1995 - 1996 Corvette: Service Bulletin: Delayed Engagement (Replace Pump Cover Assembly)

Subject: Delayed Engagement (Replace Pump Cover Assembly)

Bulletin Number: 67-71-48

FIGURE 1. - HYDRA-MATIC 4L60-E TRANSMISSION IDENTIFICATION INFORMATION

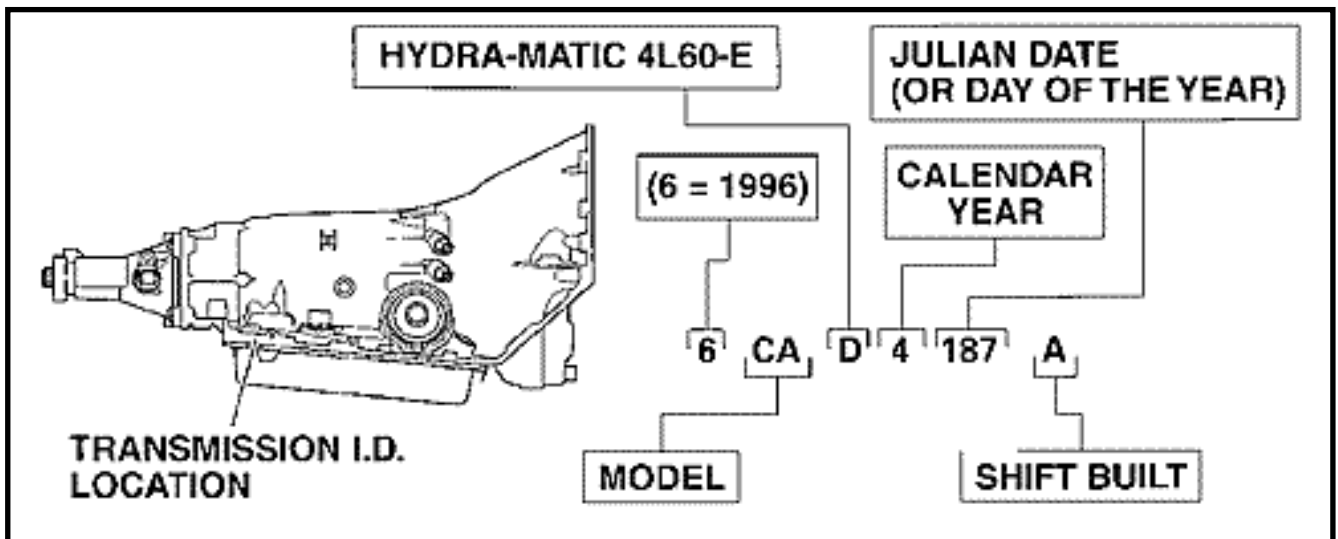
(FIGURES 1 AND 2) SOME OWNERS OF THE ABOVE MODELS, WITH A HYDRA-MATIC 4L60-E TRANSMISSION (BUILT BEFORE APRIL 29, 1996/JULIAN DATE 6120), MAY EXPERIENCE SOME DELAYED ENGAGEMENT WHEN VEHICLE IS NOT USED FOR MORE THAN 48 HOURS.

FIGURE 3. - TORQUE CONVERTER CLUTCH SIGNAL VALVE ASSEMBLY LOCATION

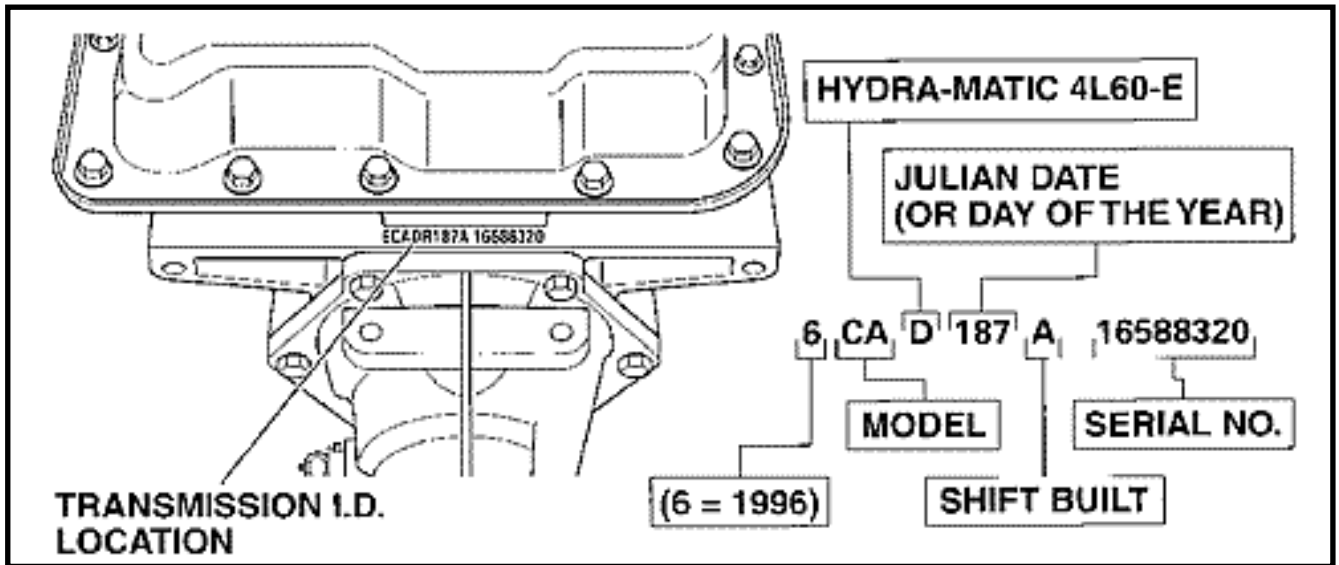
TORQUE CONVERTER FLUID LEVEL LOW DUE TO FLUID DRAIN DOWN.

(FIGURE 3) REPLACE PUMP COVER ASSEMBLY WITH THE NEW TCC SIGNAL VALVE ASSEMBLY.
